Reply to RC1

Reply to RC2

Figure 1: Emilia-Romagna's coast in the northeast of Italy. Yellow dots represent Porto Corsini's tide gauge (north) and Nausicaa's wave buoy (south). Red rectangle represents the modeled area in the town of Cesenatico. © Google Maps

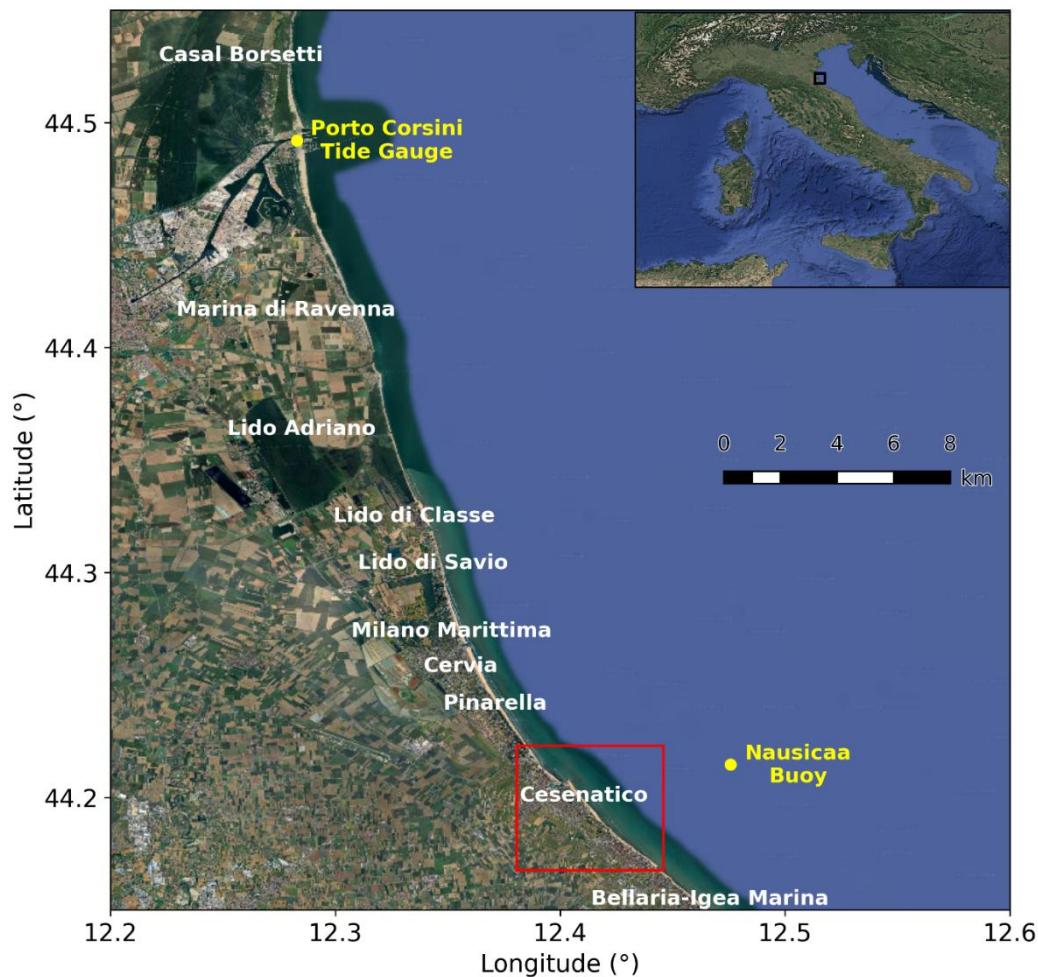
Line 160. Insert some toponyms in Figure 3 and a scale bar.

We thank the reviewer for this helpful suggestion. We have added relevant toponyms and a scale bar to Figure 3. This improvement has indeed enhanced the clarity and interpretability of the figure.
